ADDENDUM NO. CC-1

TELEGRAPH DISTRICT
401 BUILDING RENOVATION
LINCOLN, NEBRASKA
DLR GROUP PROJECT NO. 10-16202-00

February 26, 2016

P4.1
10-16202-00
02/26/2016
Revision
Addendum 1 03/11/16

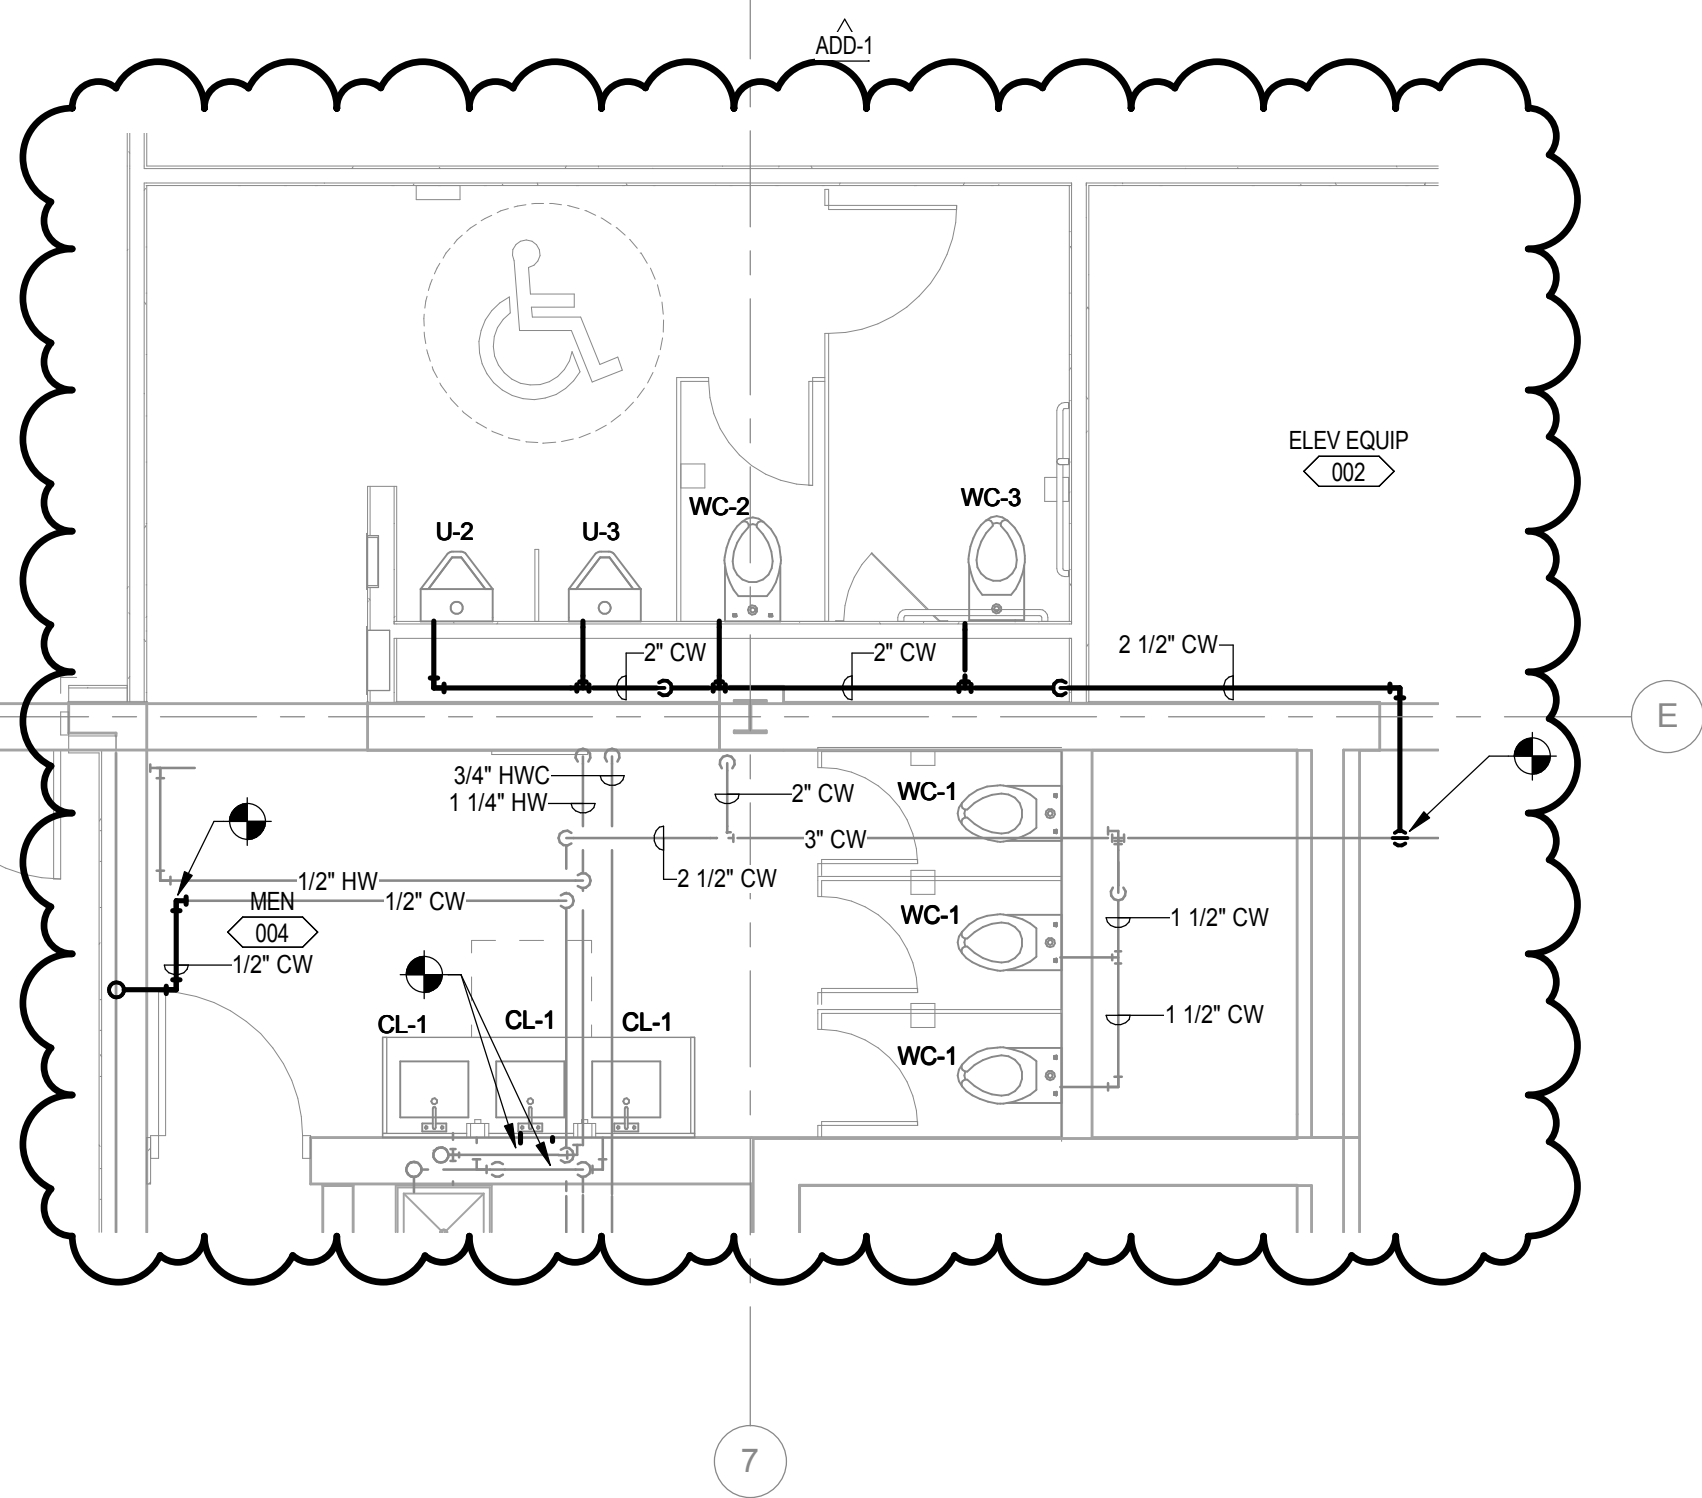
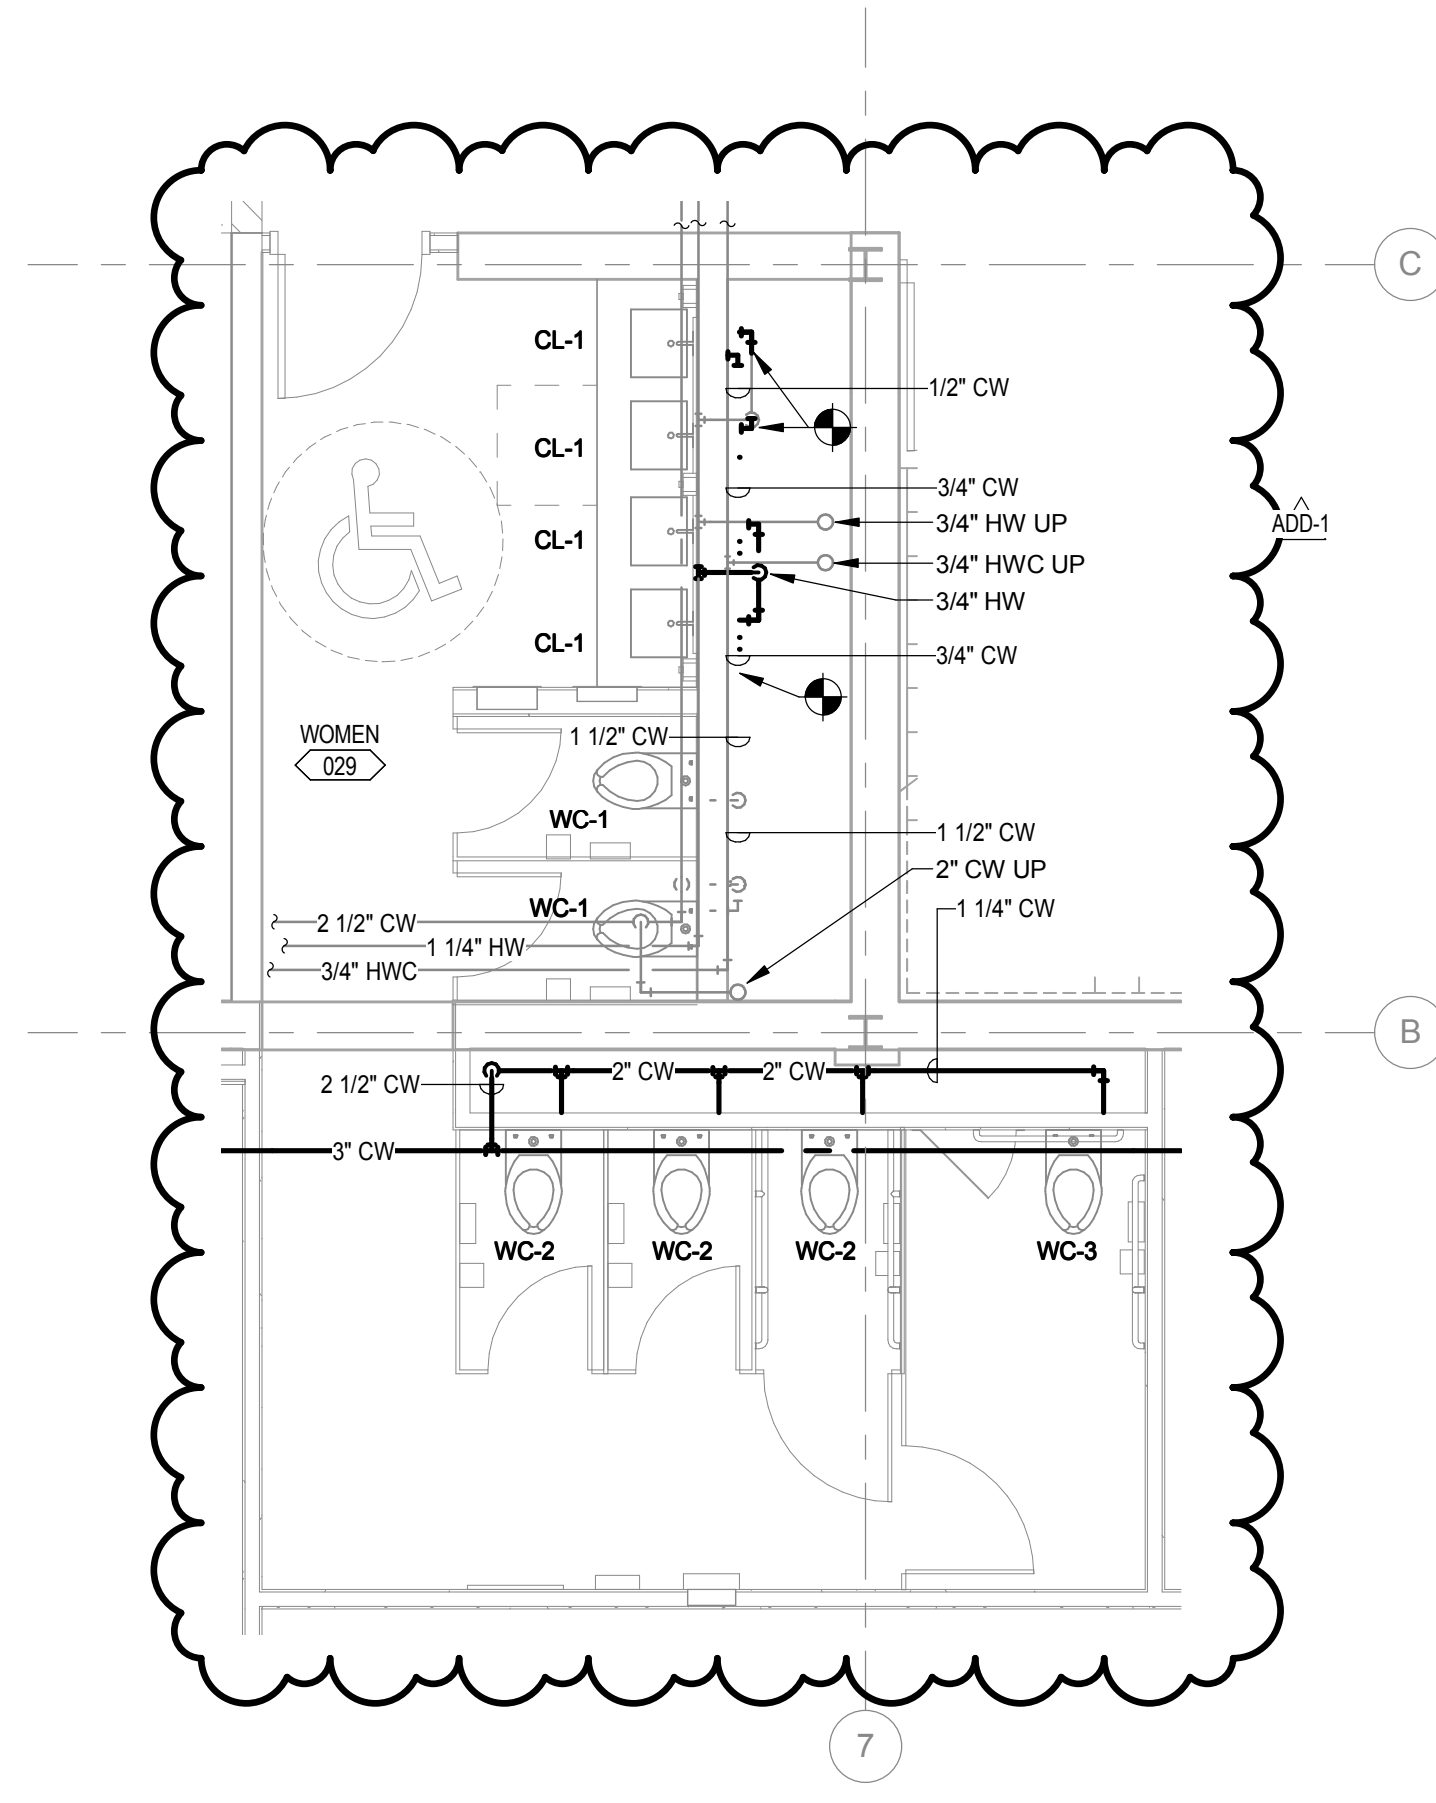
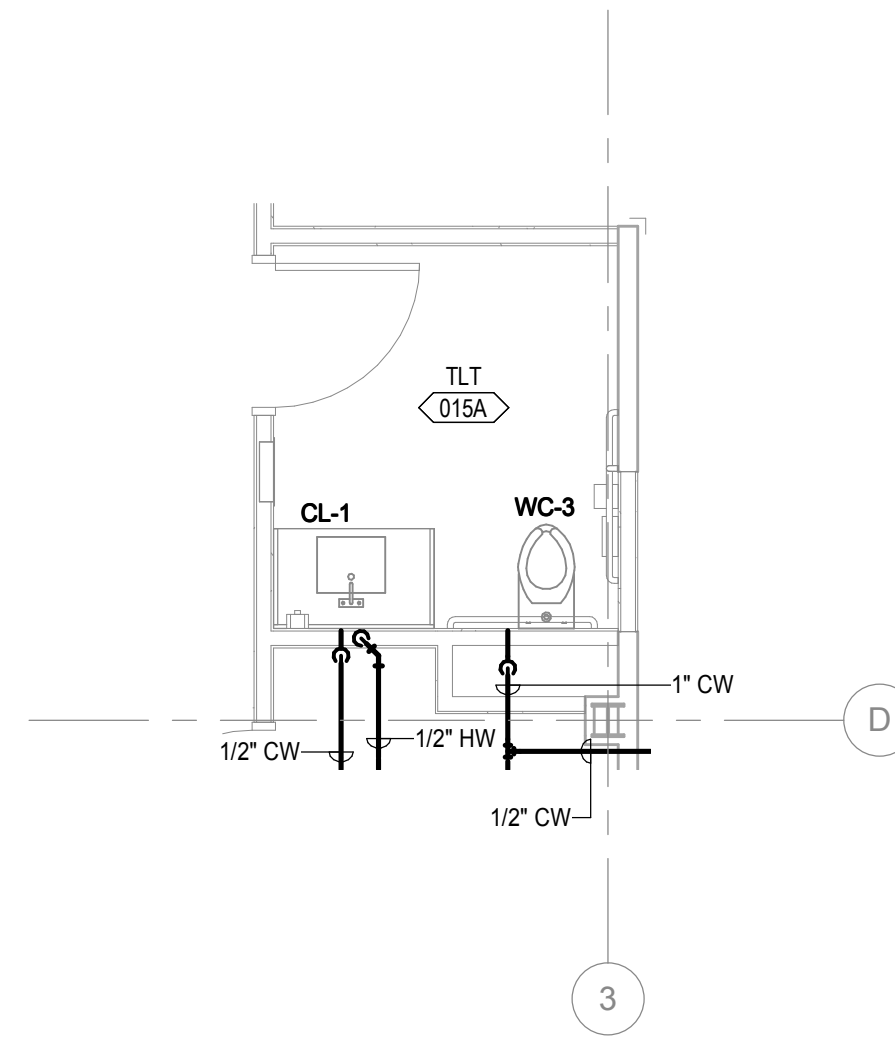
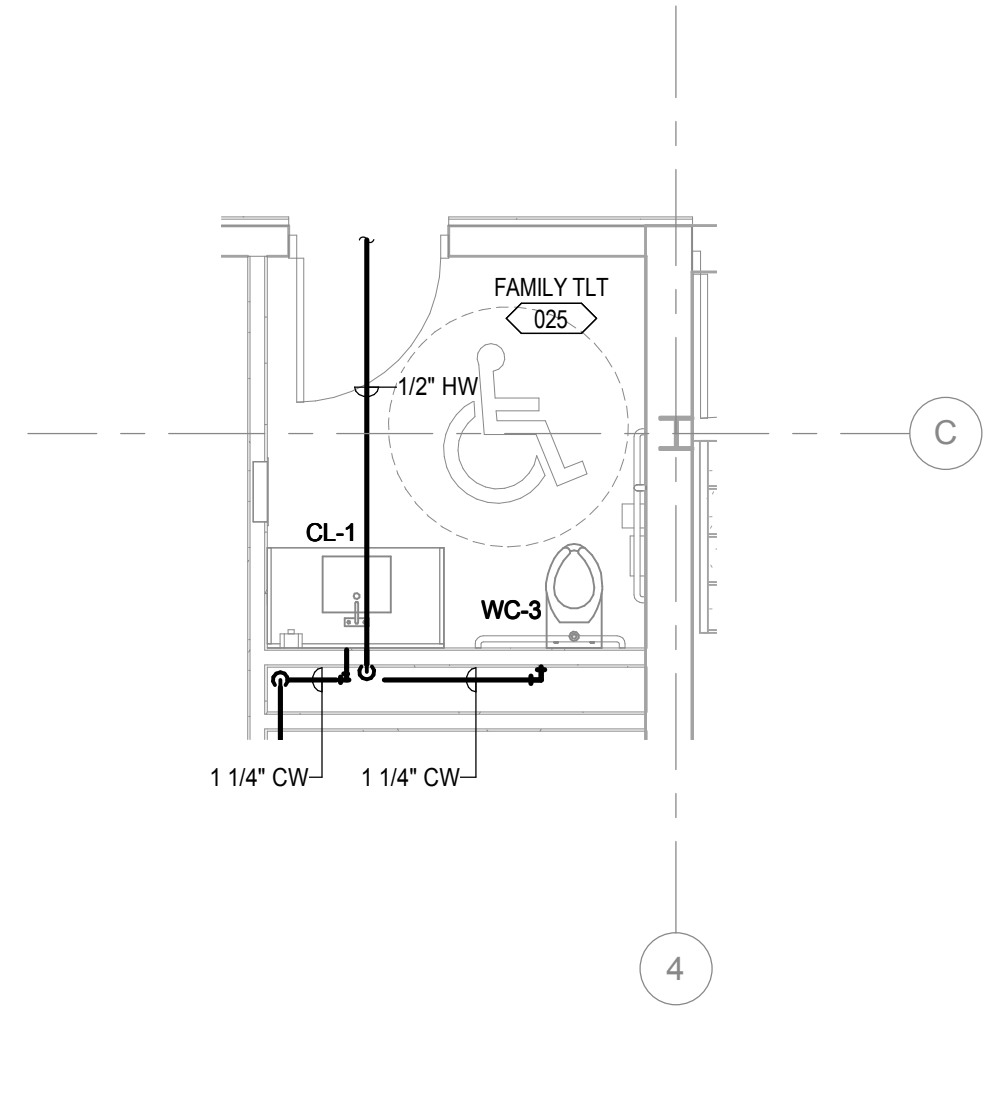
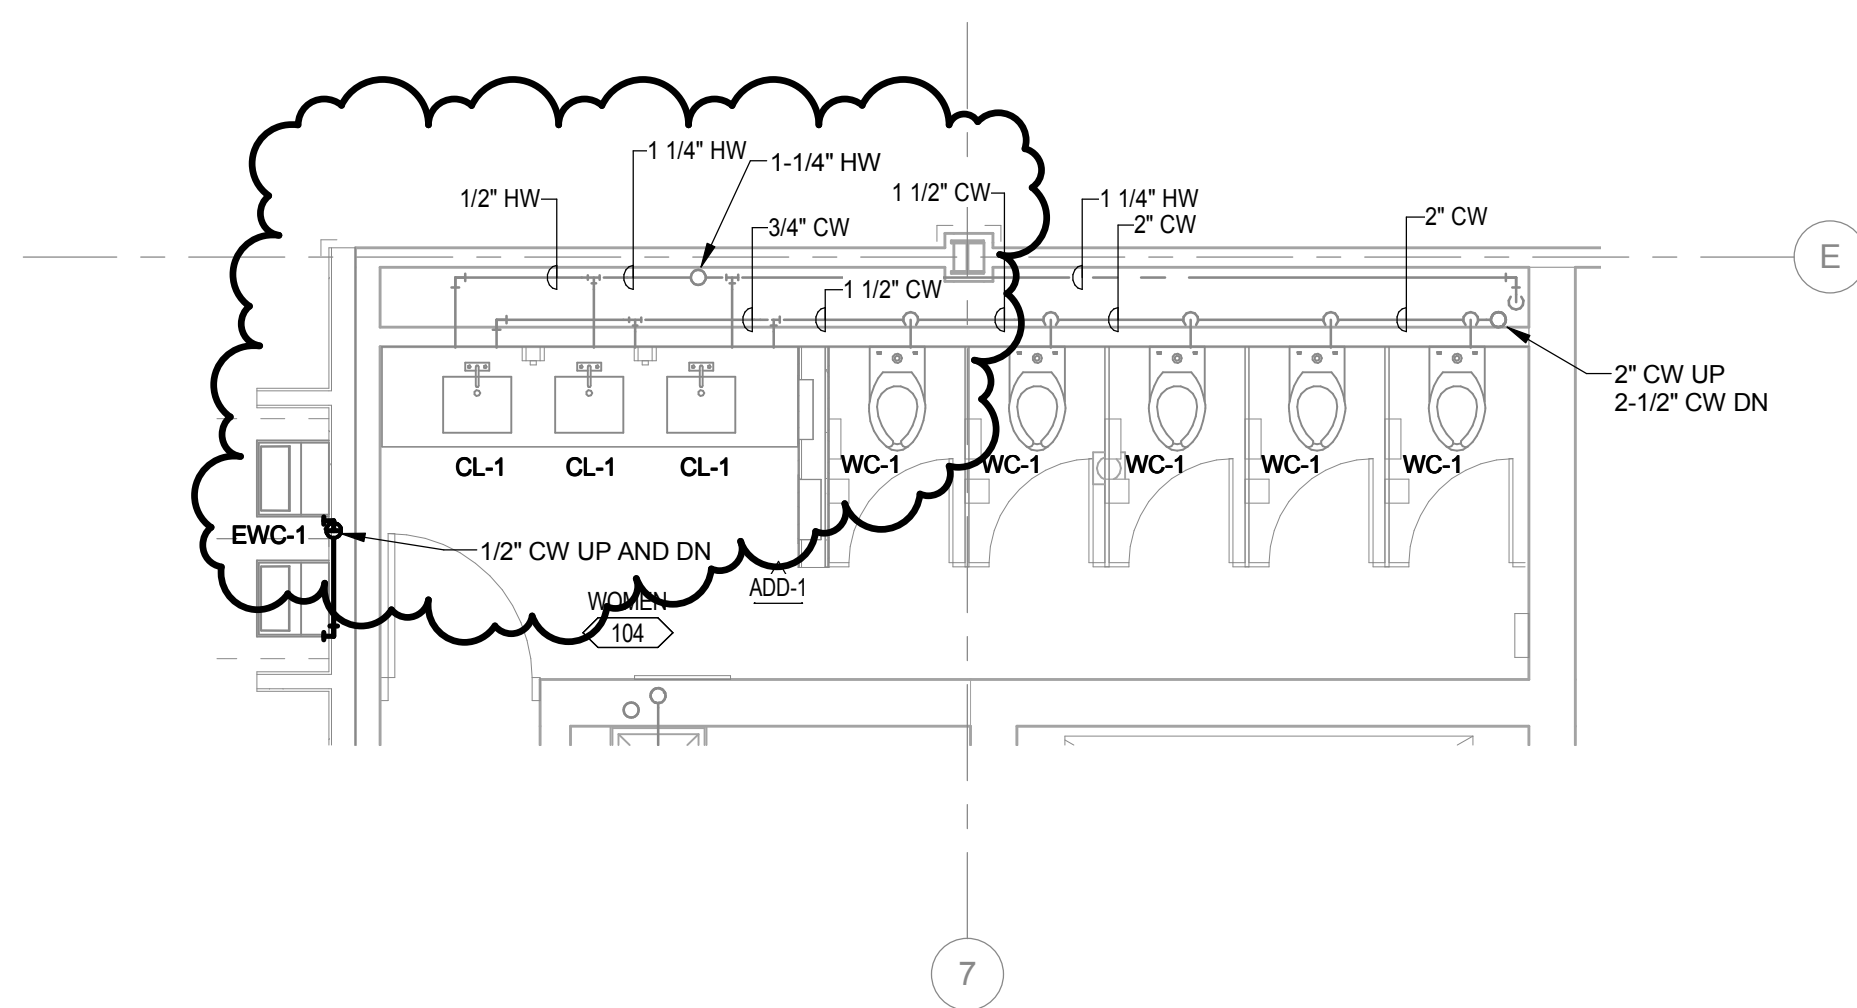
ITEM NO. 13 DRAWING P4.1 ENLARGED PLUMBING PLANS

- A. Revise the drawing as shown in the attachment P4.1 for modifications to the plumbing plan.
- B. Additional information has been added to clarify balancing valve locations and pipe sizing.
